TO: Mercedes-Benz Dealer Principals, General Managers, Sales Managers, Service Managers, Parts Managers	FROM: Thomas Brunner, Department Manager, Vehicle Compliance and Analysis, Engineering Services
RE: Recall Campaign 201502003-Retrofit Headlamp Adjustment Screw Caps. Model 205 (C-Class Sedan) Model Year 2015	DATE: May 6, 2016

Campaign No. 2015020003, May 2016

SUBJECT: **Model 205 (C-Class), Model Year 2015**
Retrofit Headlamp Adjustment Screw Caps

Figure 1

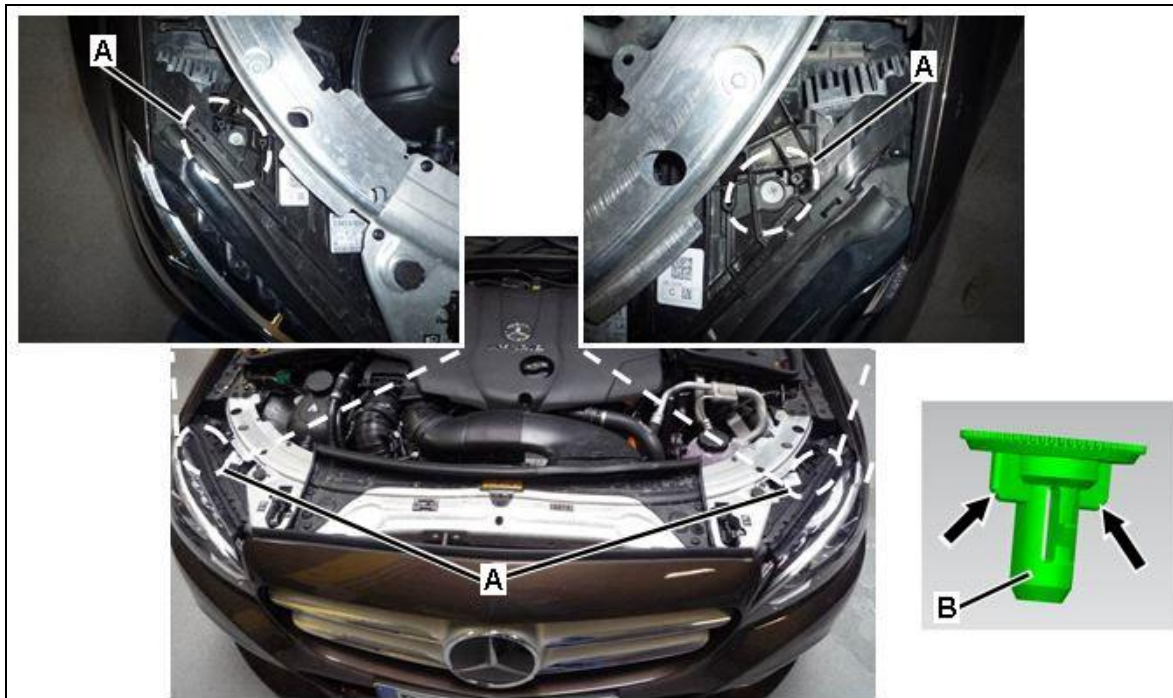
Daimler AG (DAG), the manufacturer of Mercedes-Benz vehicles, has determined that the headlamps might not meet the requirements of Federal Motor Vehicle Safety Standard (FMVSS) 108, which requires that headlamps with low beams must not have a horizontal adjustment mechanism. The subject vehicles are designed to meet this requirement by sealing off the headlamp horizontal adjustment screw with a non-removable sealing cap after initial adjustment in the manufacturing plant. The sealing cap may not have been installed on these vehicles. An authorized Mercedes-Benz dealer will retrofit the two sealing caps.

1. Open hood.
2. Retrofit cap (B, Figure 1) for headlamp adjustment screws (A) at left and right:
 - Position cap (B, Figure 1) on headlamp adjuster (A) so that the tabs (arrows) on the cap (B) align with the grooves in the adjuster (A).
 - Press the cap (B) into adjuster (A) by hand until it locks into position.

An audible click will be heard when the cap (B) is properly seated into the adjuster (A).
